T10/1826-D

Revision 05
22 June 2008

Information technology - SCSI / ATA Translation - 2 (SAT-2)

Summary of Comments on SCSI / ATA Translation Standard

Figure 2 — ATA document structure

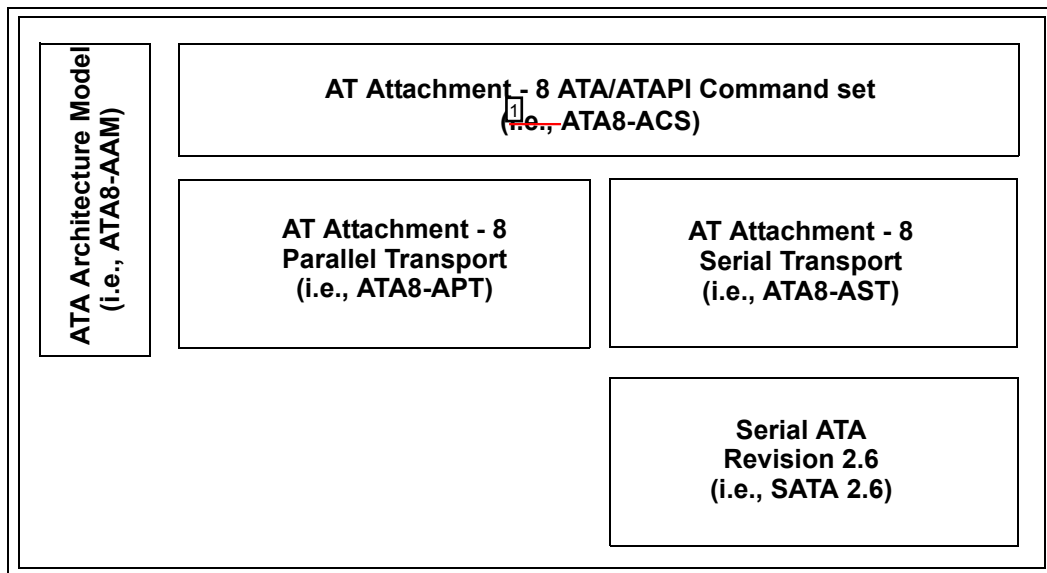
Delete all the "i.e.,"s from figure 2. That is not used for acronyms in parenthesis - just the acronym is fine, like "(ATA8-ACS)"

Figure 3 — SCSI / ATA Translation document role

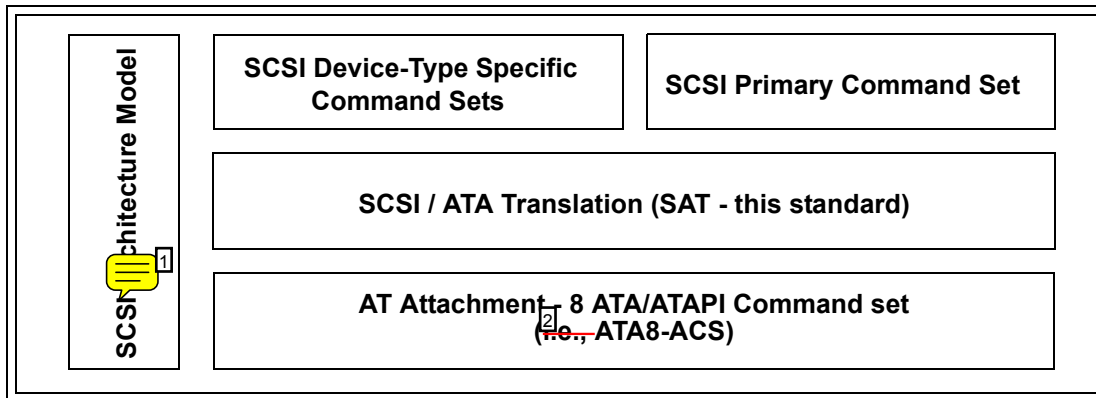
Number: 2 Author: HPQ-RElliott Subject: Cross-Out Date: 9/3/2008 9:42:24 AM
Delete i.e., in figure 3 (see reasoning in comment on figure 2)

Figure 10 — Translation of Logical Sector Alignment (part 3)

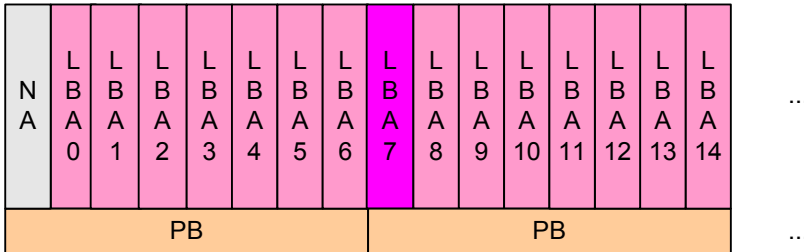
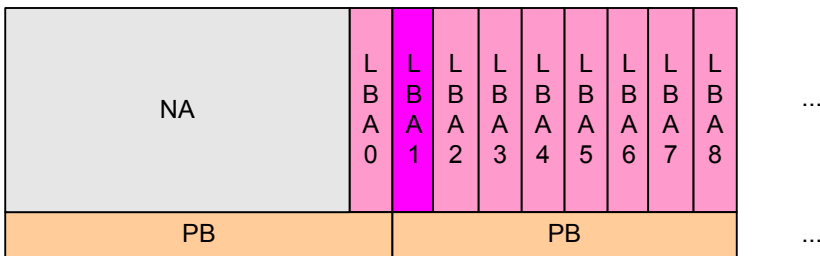
Number: 1 Author: Kevin_Marks Subject: Highlight Date: 8/11/2008 12:51:30 PM
Figure 10 missing reference in text

Figure 8 — REASSIGN BLOCKS command translation

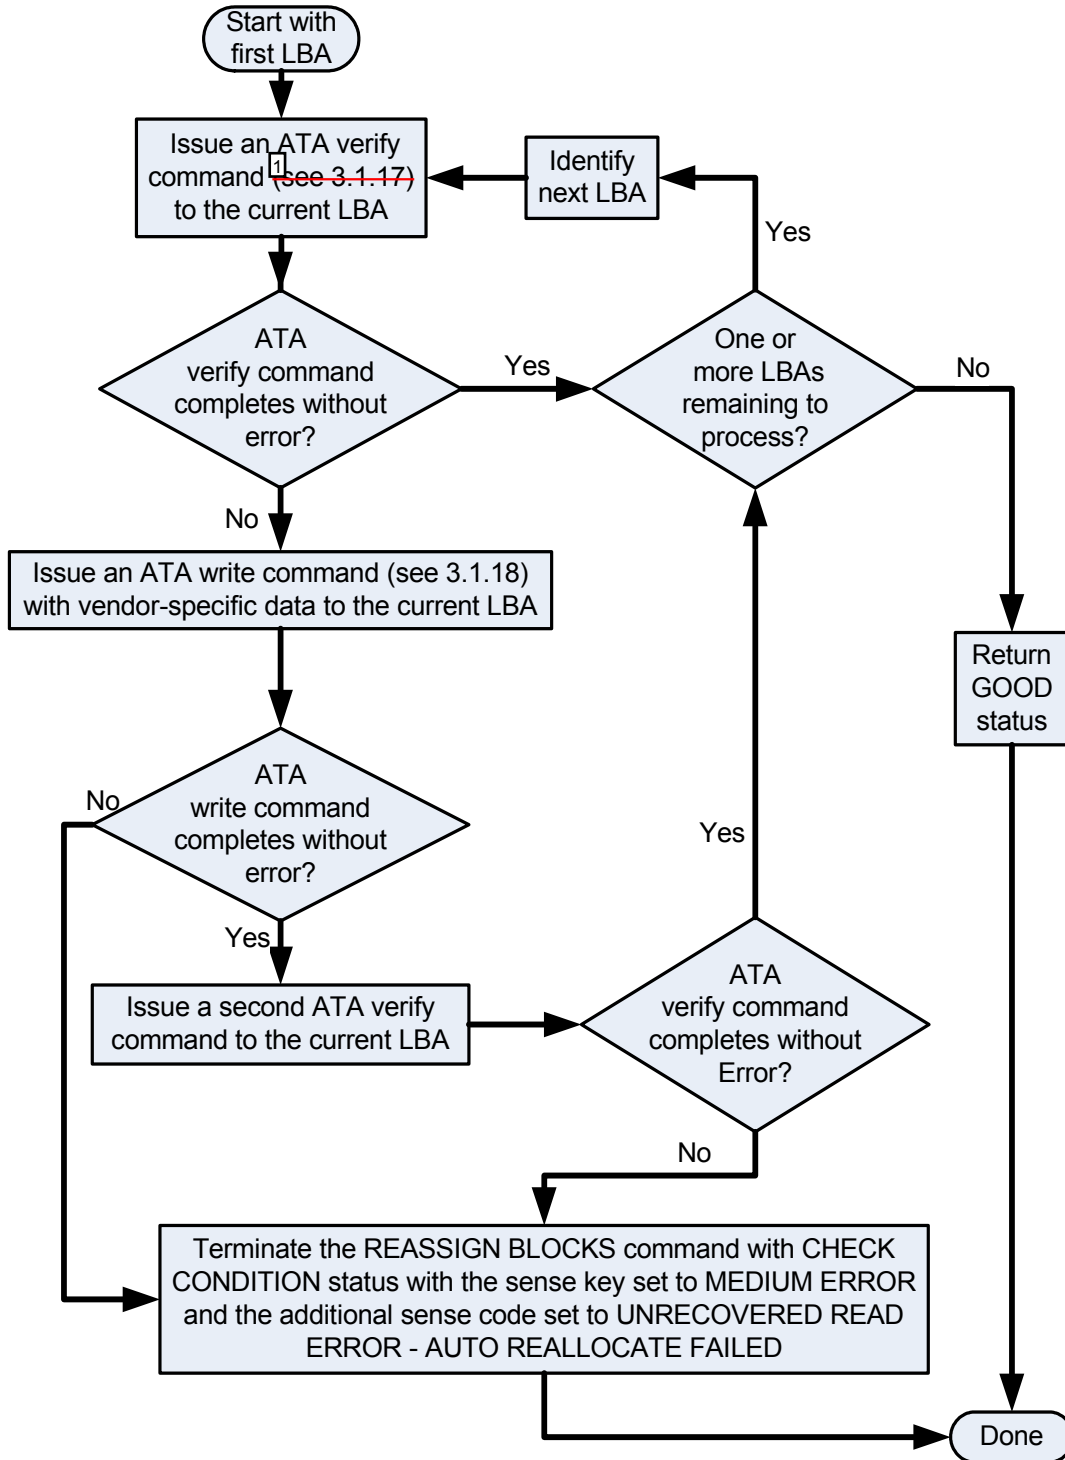
Cannot create active cross references to Frame sections inside Visio figures, so better to leave these out.

Figure 9 — ³identification descriptors included by a SATL in an ATA host

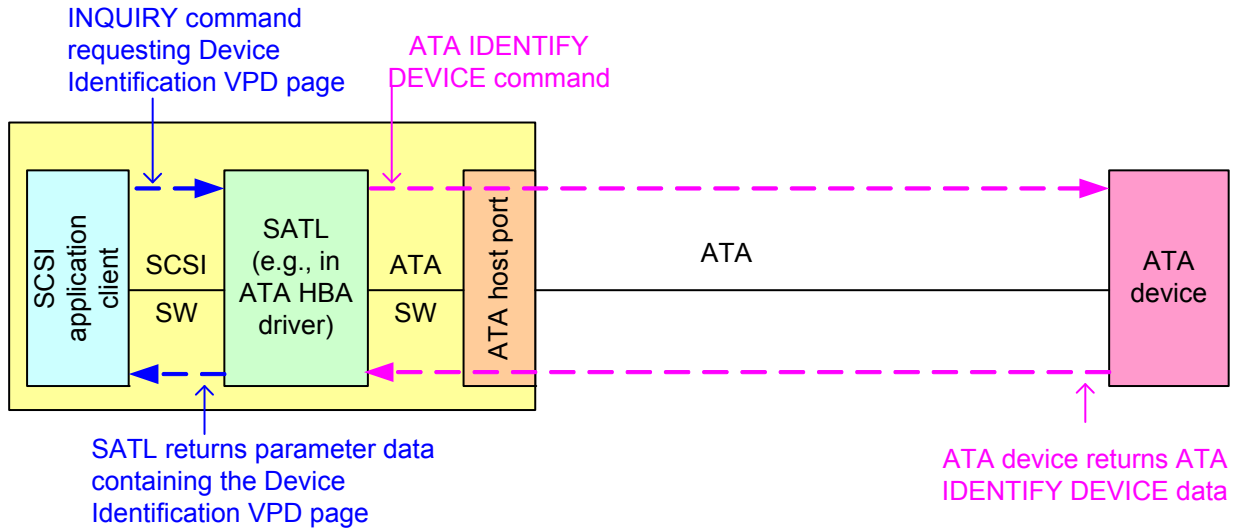
-
- T** Number: 1 Author: Kevin_Marks Subject: Highlight Date: 8/27/2008 11:35:19 AM
identification
s/b
designation
-
- T** Number: 2 Author: Kevin_Marks Subject: Highlight Date: 8/27/2008 11:35:32 AM
identification
s/b
designation
-

Figure 11 — Identification descriptors included by a SATL in a SCSI to ATA protocol bridge

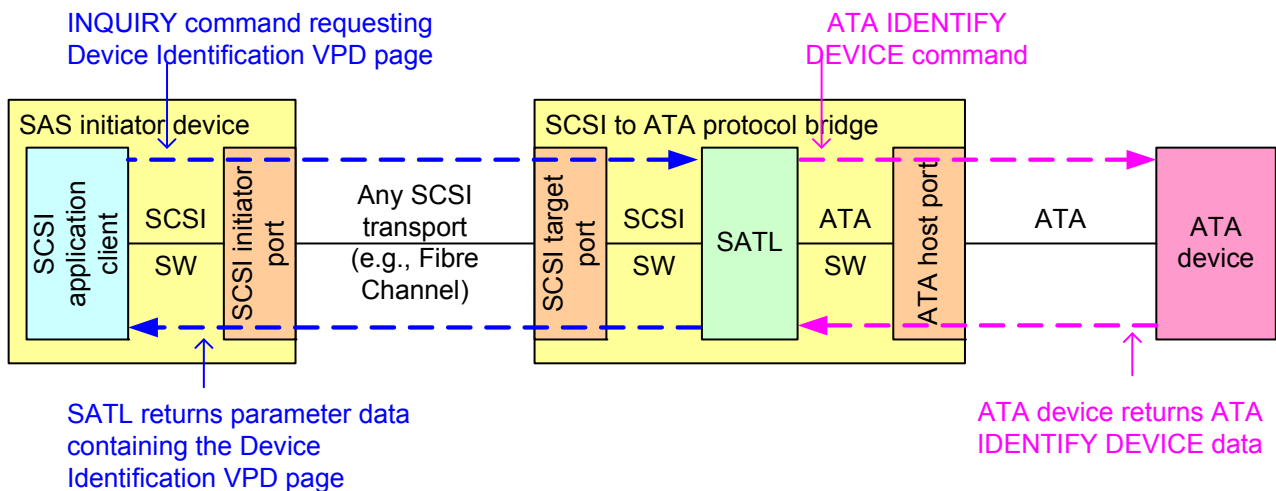
-
- I** Number: 1 Author: HPQ-RElliott Subject: Highlight Date: 9/3/2008 9:42:24 AM
 IDENTIFIER TYPE
 s/b
 DESIGNATOR TYPE
-
- I** Number: 2 Author: Kevin_Marks Subject: Highlight Date: 8/27/2008 11:41:07 AM
 IDENTIFIER
 s/b
 DESIGNATOR
-
